# UNITED STATES PATENT AND TRADEMARK OFFICE

APPLICATION NO.	FILING DATE	FIRST NAMED INVENTOR	ATTORNEY DOCKET NO.	CONFIRMATION NO.
10/623,843	07/21/2003	Veronika Polei	P2002,0618	6526
24131	7590	06/01/2005	EXAMINER	
LERNER AND GREENBERG, PA P O BOX 2480 HOLLYWOOD, FL 33022-2480			NGUYEN, KHIEM D	
			ART UNIT	PAPER NUMBER
			2823

## Office Action Summary

## DETAILED ACTION

**FIG. 3**

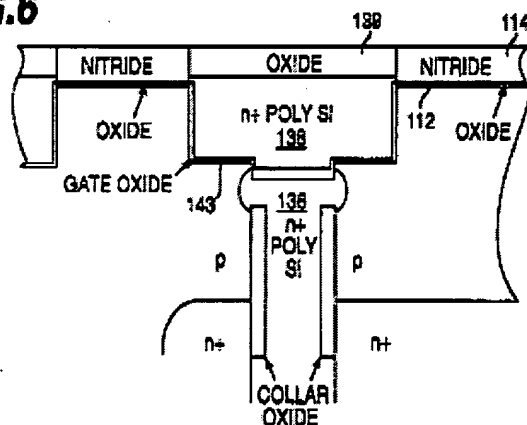
In re claim 1, **Horak** discloses a method for fabricating a buried bit line for a semiconductor memory, which comprises: producing strip-like doped regions parallel to and at distances from one another in a semiconductor body **110**, the regions being adapted to act as bit lines and as source/drain regions of a respective memory transistor (col. 5, line 60 to col. 6, line 23 and FIG. 3);

applying laterally with respect to the doped regions, in each case, one layer sequence adapted to act as a gate dielectric (ONO) and including a lower boundary layer (oxide) 112, a storage layer (nitride) 114, and an upper boundary layer (oxide) 116 (col. 6, lines 23-34 and FIG. 3);

**FIG. 6**

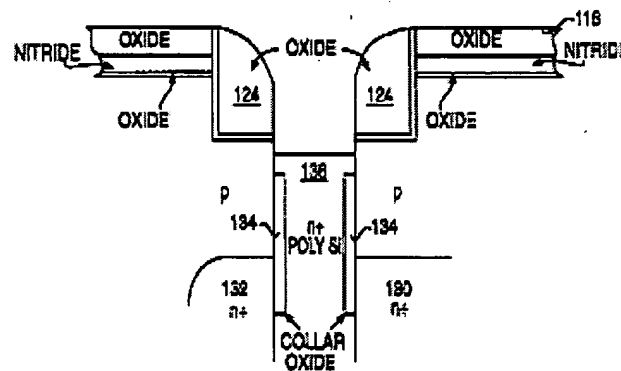
forming an oxide region 139 in each case on a side of the doped regions remote from the semiconductor body 110, the oxide region 139 being thicker than the lower boundary layer 112 (col. 7, lines 18-36 and FIG. 6);

before the upper boundary layer 116 is applied, and after the application of the storage layer 114, applying a sacrificial layer made from a material selectively etchable with respect to a material of the storage layer and to polysilicon onto the storage layer (col. 7, lines 18-24);

**FIG. 5**

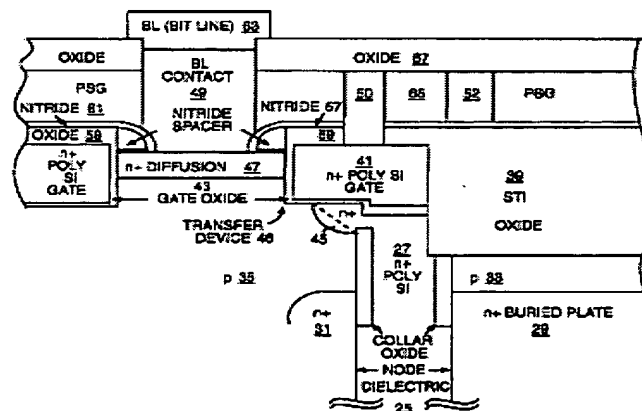
producing openings **118** in the sacrificial layer, the storage layer **114**, and the lower boundary layer **112**, extending the semiconductor body **110**, by using a mask (col. 6, lines 34-65);

introducing doped polysilicon (**n+ POLY Si**) into the openings **118** (col. 6, line 66 to col. 7, line 9 and FIG. 5);
